RE: BZA Case 18990  
Square 1664, lot 30

BZA Case 18990

**OPTION 4**

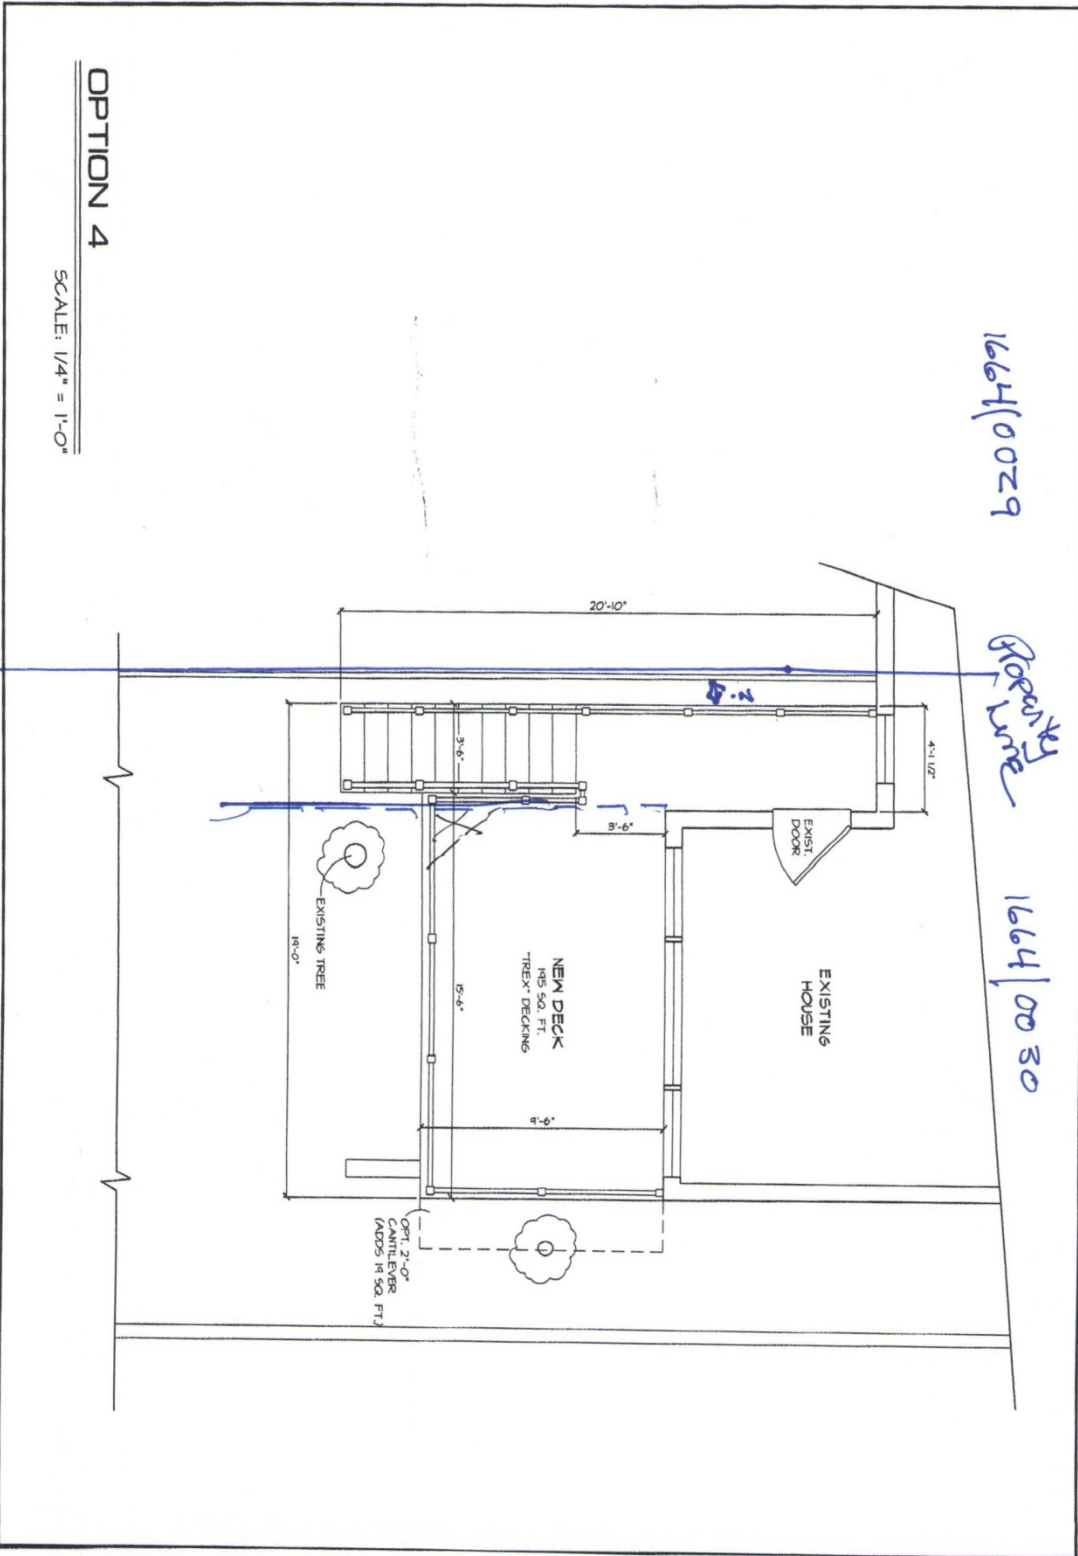
Of the various options provided, Option 4 (attached) is the only one that begins to address, but does not fully alleviate, my concerns.

1. Privacy – outdoor living spaces, by their nature, have a potentially negative impact on the privacy of neighboring properties. I would therefore request that the landing be a minimum of 10" inside the property line on the applicants' side and that the deck proper be a minimum of 4' 3" feet from my property line. This would allow an entrance from the landing to the deck not to exceed 3'6" in width. It is my understanding that the proposed deck will not extend beyond the depth of my porch. Locating the stairs on the east side

– in their original location, opposite my staircase would help to maintain the desired buffer between living spaces.

2. Light – restoring the stairs in their original configuration, with open risers, should allow some light into my basement. Because basement light is dependent on afternoon sun, a deck deeper than the one removed will block light and sun so I would suggest angling the corner of the deck to permit light to reach my basement.

I note that the applicants' preference is to locate the stairs on the west side. Doing so, or extending the deck with the cantilevered option, will eliminate an opportunity for planting and greenspace. I also have concerns that granting a variance will set a precedent that encourages future expectations of similar relief. If granted, I would like to ensure that any variance is very specific and limited in scope. These houses, built in the 1920s when the scale of housing was smaller, sit on lots smaller than the current minimum required lot size.
